# City of Mississauga Department Comments

Date Finalized: 2023-01-18	File(s): A90.22
To: Committee of Adjustment	Ward: 8
From: Committee of Adjustment Coordinator	Meeting date:2023-01-26 1:00:00 PM

**Property Address:** 4056 Barbican Drive

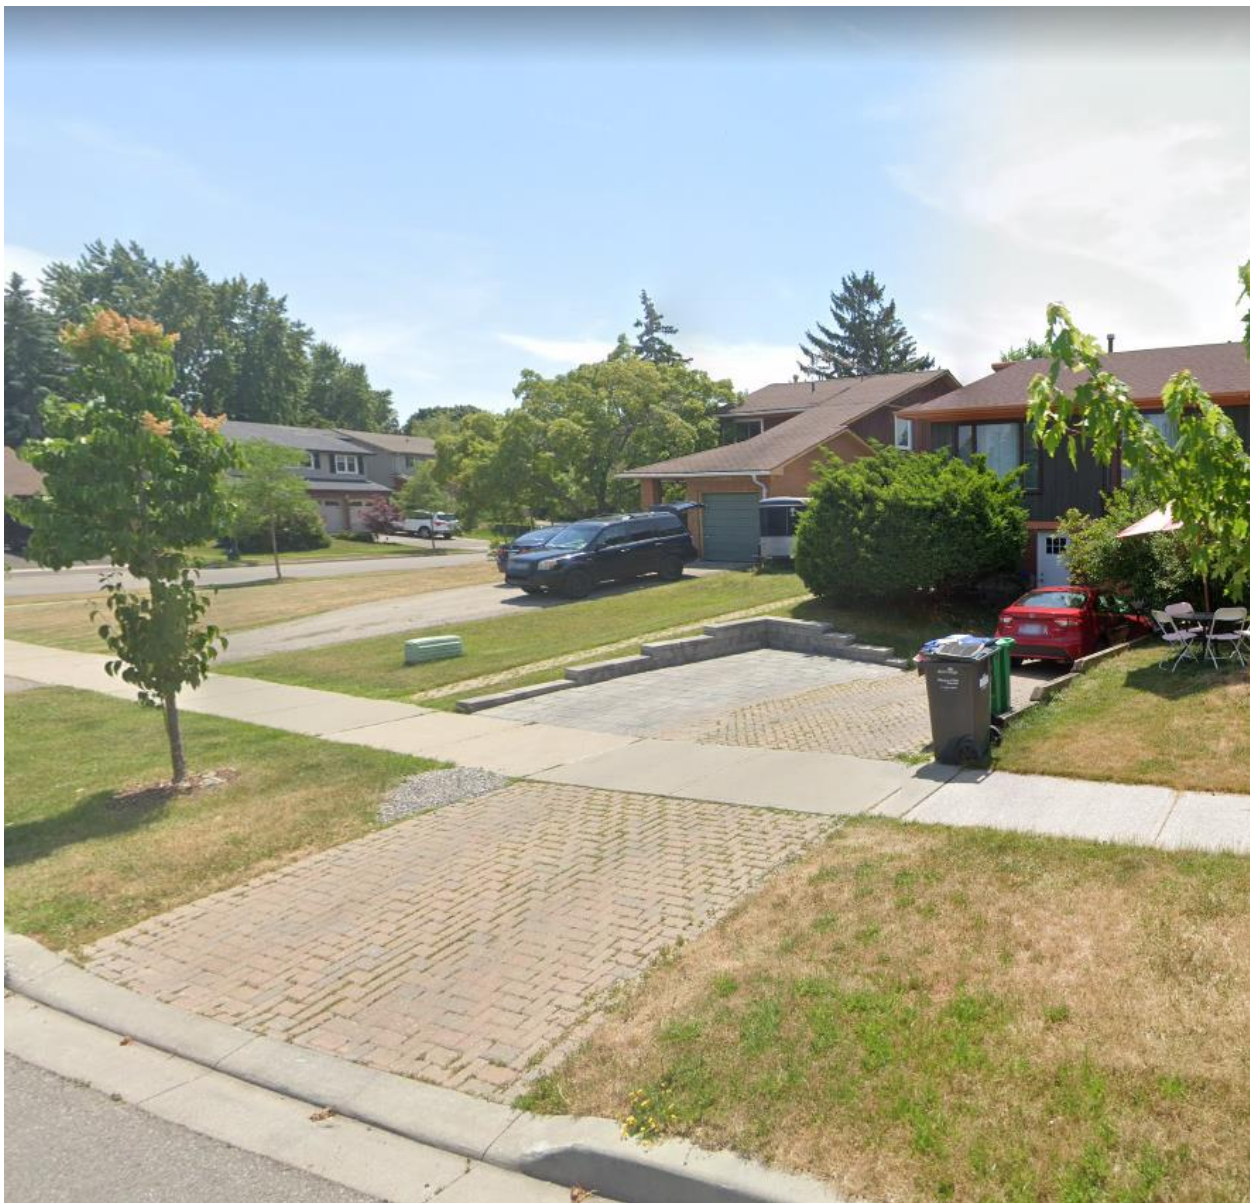
Enclosed for Committees information is a current photo of what the completed driveway extension looks like. We have no drainage related concerns, although we do question how a vehicle can safely enter/exit the parking spot without encroaching over the boulevard sodding when there are two vehicles parked in tandem on the driveway. From the photo you can see that the owners have already placed gravel over a small corner of the sodded area.
